Retrofit Emission Control Devices (REC)

Proposal for an amendment to Regulation No.[..]

Submitted by the chairman of the informal working group on Retrofit Emission Control devices (REC)

Draft rev.01 Version 4 dated 20.02.2013

Model A

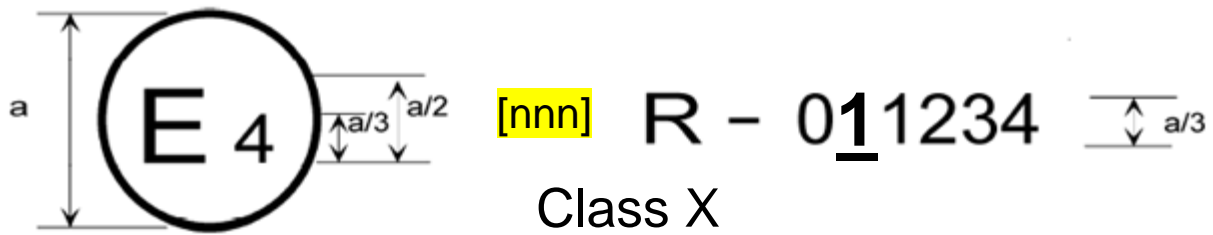
Annex 3 is replaced by

The above example approval mark affixed to a REC shows that the type concerned has been approved in the Netherlands (E 4), pursuant to Regulation No. [nnn] under approval No. 0011234. The first two digits of the approval number indicate that the approval was granted in accordance with the requirements of Regulation No. [nnn] ~~in its original form~~ **in the form as amended by this revision.** The approval mark shall also show the Class of REC (I, II, III or IV)
